REGIONAL REVIEW FINDING

ARC REVIEW CODE: R706041

Name of Proposal: The Heights at Clairmont (Fairfield at Clairmont)

Preliminary Report:	June 4, 2007	DEVELOPMENT OF REGIONAL IMPACT REVIEW REPORT	Project:	The Heights at Clairmont # 1387
Final Report Due:	July 4, 2007		Comments Due By:	June 18, 2007

PROPOSED GRTA DRI PLAN
CLAIRMONT LODGE
Land Lots 196 & 197 – 18th District
DEKALB COUNTY, GEORGIA

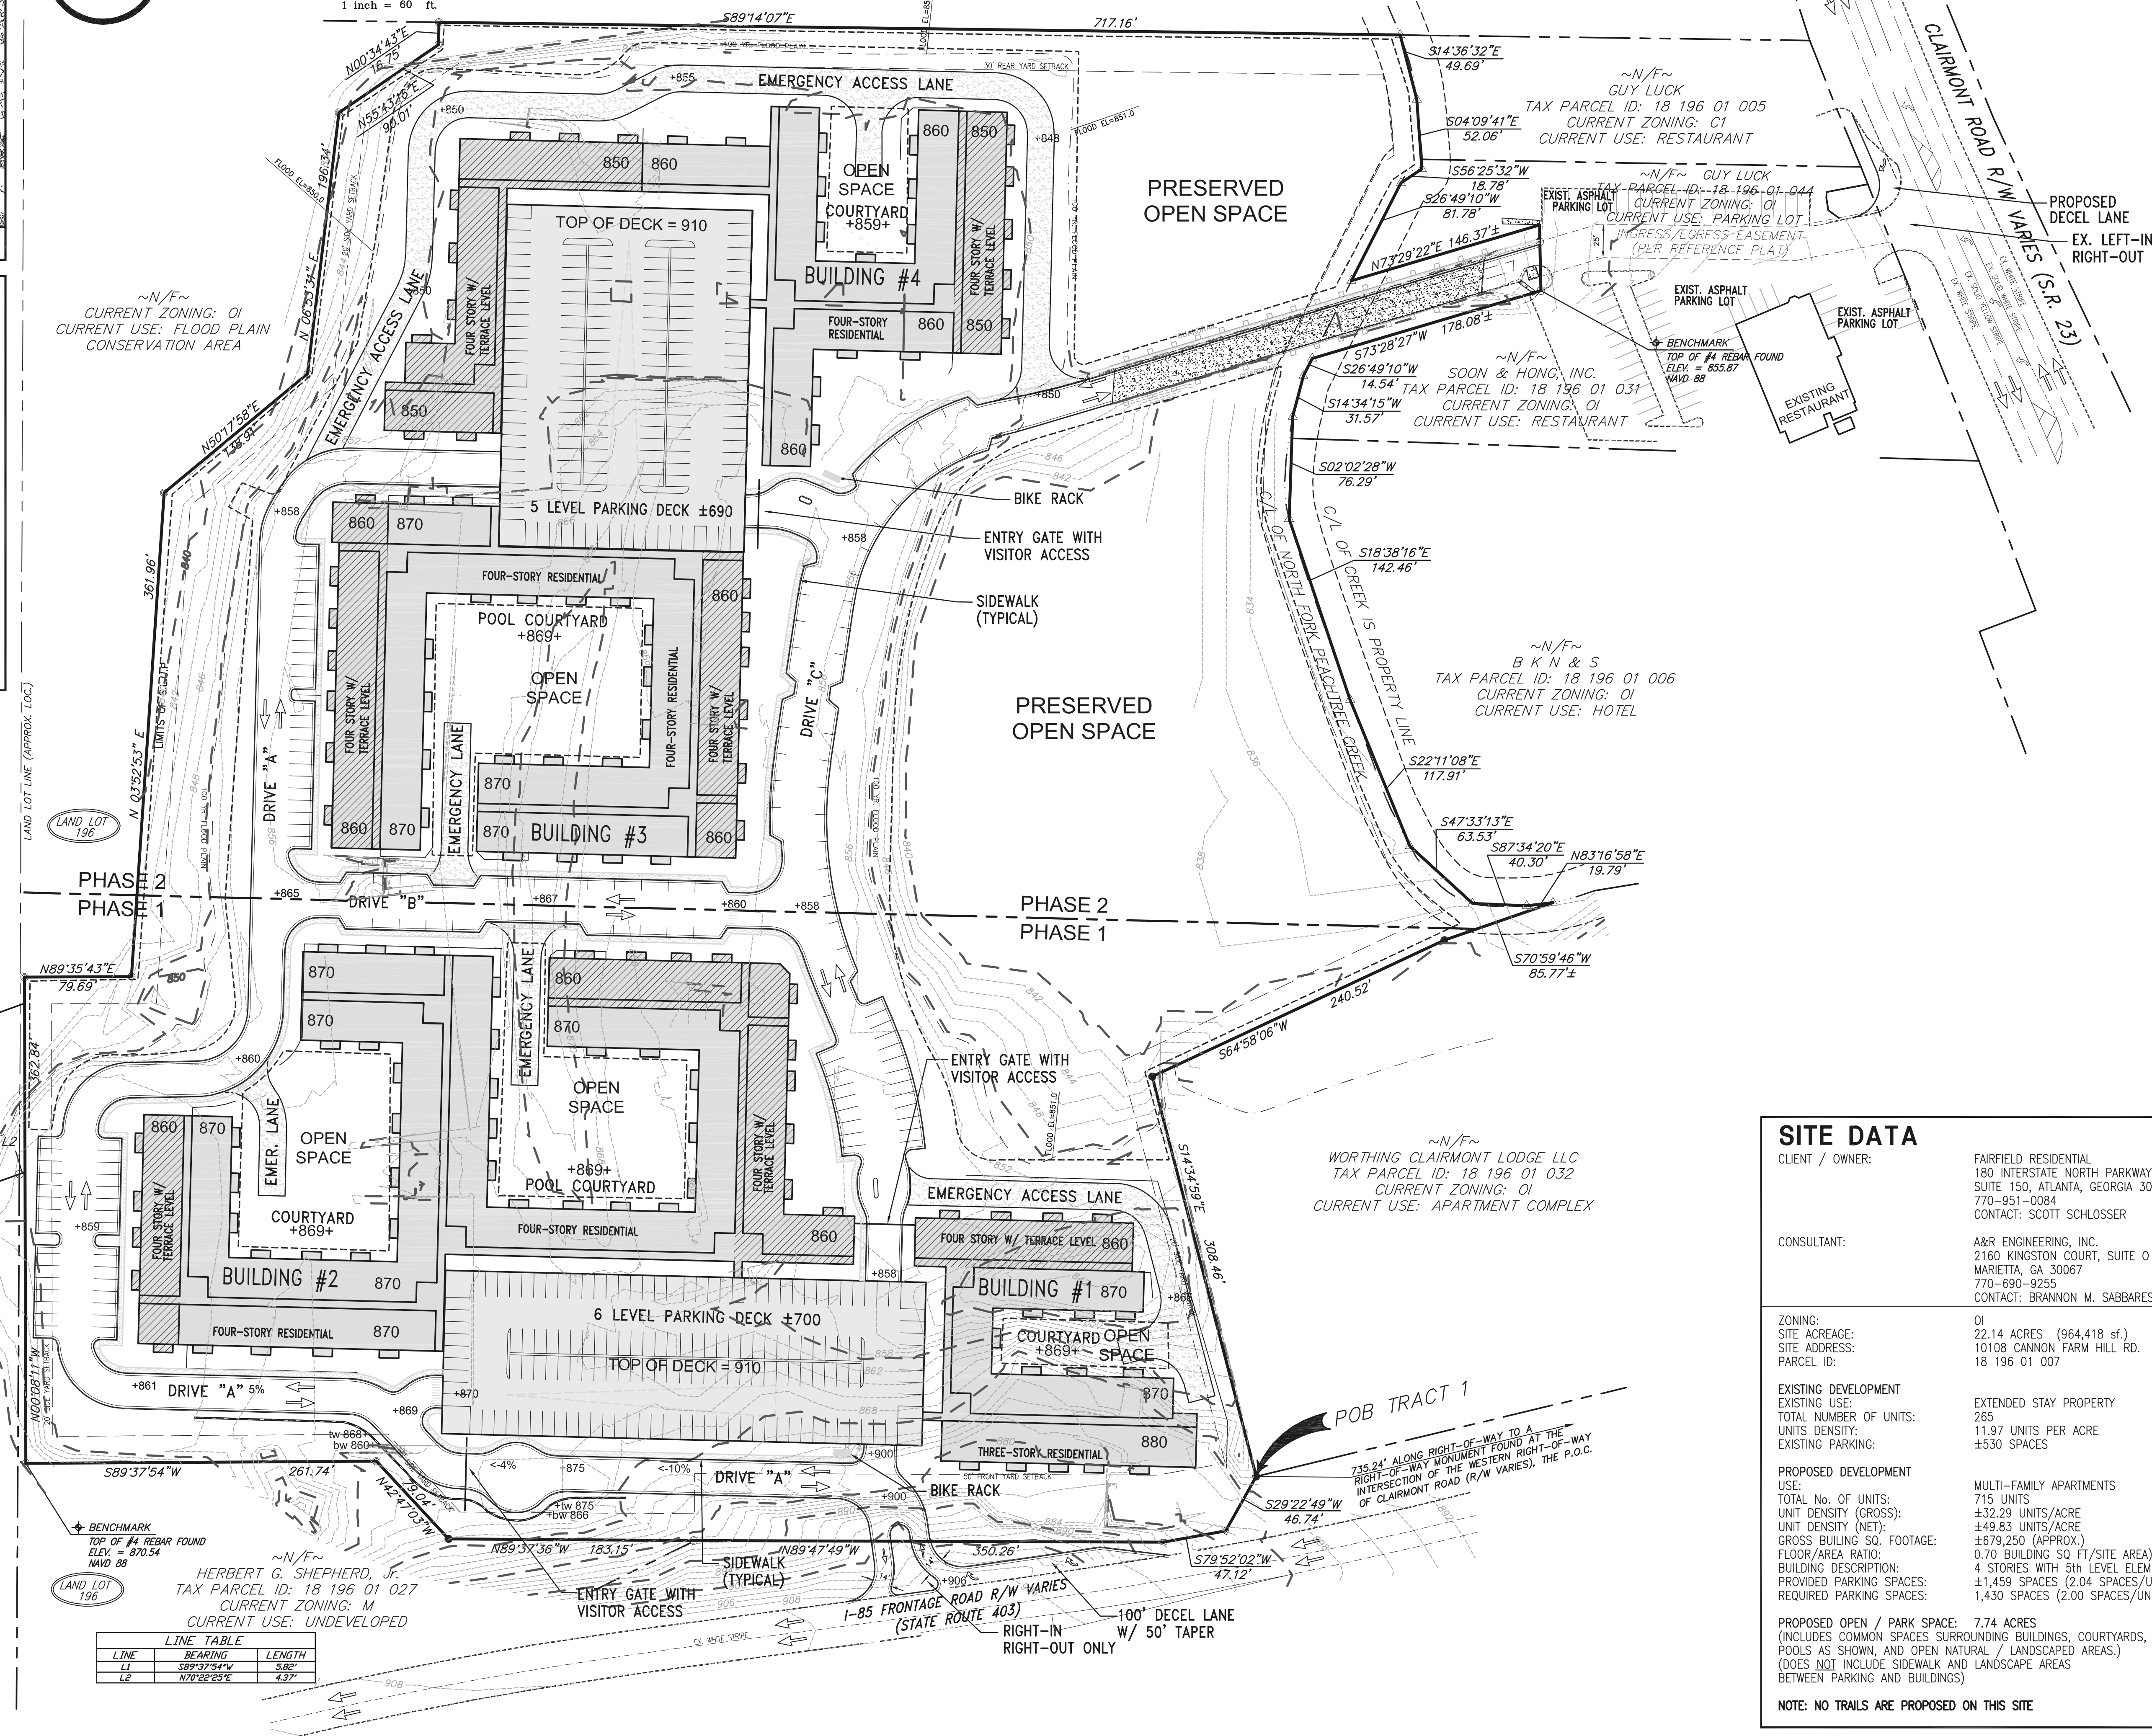
It is important that stub outs to adjacent development are provided for future street connections as it is likely that other properties within the immediate area will redevelop. Connections should be considered to adjacent properties labeled Doug Smith, G F Investments, and Worthing Clairmont Lodge, as shown on the site plan.

The North Fork of Peachtree Creek runs along eastern side of the project property. While the 75-foot DeKalb County stream buffer is not shown, all new development on the property, except for any improvements to or replacement of the existing bridge over the stream, is more than 160 feet from the stream. Any unmapped streams that may be on the property will also be subject to the DeKalb County stream buffer ordinance. All state waters on the property will be subject to the 25-foot Erosion and Sedimentation Act buffers, which are administered by the Environmental Protection Division of Georgia DNR. Any work within these buffers will require a variance from Georgia EPD.
